Site Address: 23 NAUTILUS CT SAC

Nature of Work: TEAR OFF, RESHEET & REROOF 38 SQ LT WT CONC TILE FOR SFR W/
GAR

1 **ROOF PLAN - OKINO**
Not to Scale
[Handwritten number 6]

Subject: Structural Investigation Report of the Roof for the Residence located at 123 Nautilus Court,
Sacramento, CA 95831.

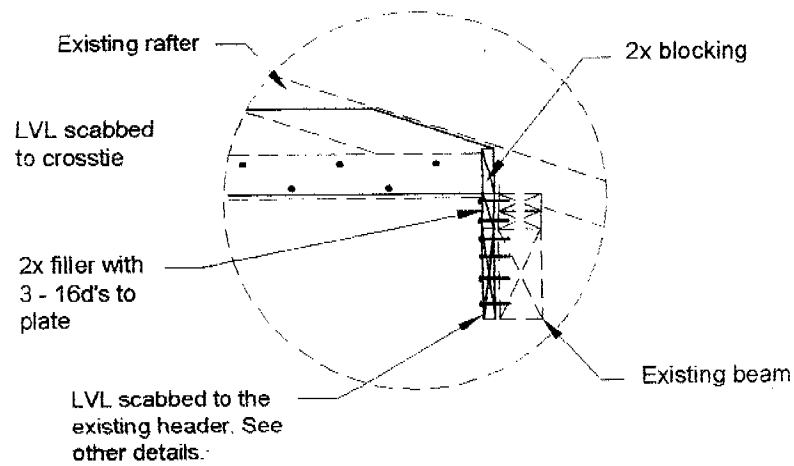
1. Scab a 1-3/4" x 11-7/8" LVL to the existing 2x6 crossie with 16d's @ 6" oc. The support at the interior wall shall be a 2x8 x 2'-8" long ledger attached to the double top plate with 16d's @ 2" oc staggered. Support the existing valley rafters to the LVL below with 2x4 struts. See detail 2.
- X Add 2x4 struts to bearing below (total 4).
